Date: JUL 1 2011 Service Letter No. 71

SUBJECT: Parking Brake Control

AIRPLANES AFFECTED: All

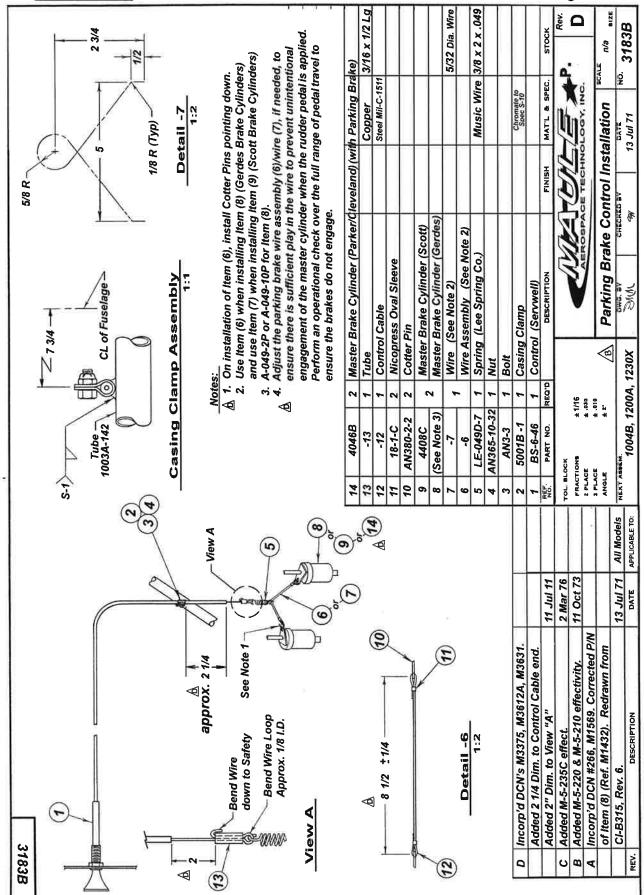
BACKGROUND: It has come to our attention that a few incidents have occurred involving the

hang-up of the parking brake cable thus engaging the brake. One cause may be not fully disengaging parking brake control by not pushing control knob com-

pletely against instrument panel for the OFF position.

- Step 1 Release parking brake control and push pedals to release locks. Make sure the cable attached to the locking levers (Item (6) or (7) Maule drawing 3183B) has no interference throughout full operating range of the parking brake control.

- Step 2 Operate the rudder pedals though their full range of travel and check for any interference of above item (6) or (7) and ensure that the locks do not engage. If any hang-ups occur, adjust per following Steps 3, 4, and 5.

- Step 3 With rudder pedals in neutral position, set cable housing to 2 ½" dimension as shown on Maule drawing 3183B.
- Step 4 Pull the parking brake knob out until the nicopress comes in contact with the cable housing.

- Step 5 The locking levers should be in full lock position and the spring (item (5) on Maule drawing 3183B) has approximately 1/8" expansion. Readjust the 2 1/4" dimension in step: 1 above as necessary for achieving this spring expansion.

- Step 6 Recheck operation per Steps 1 and 2.
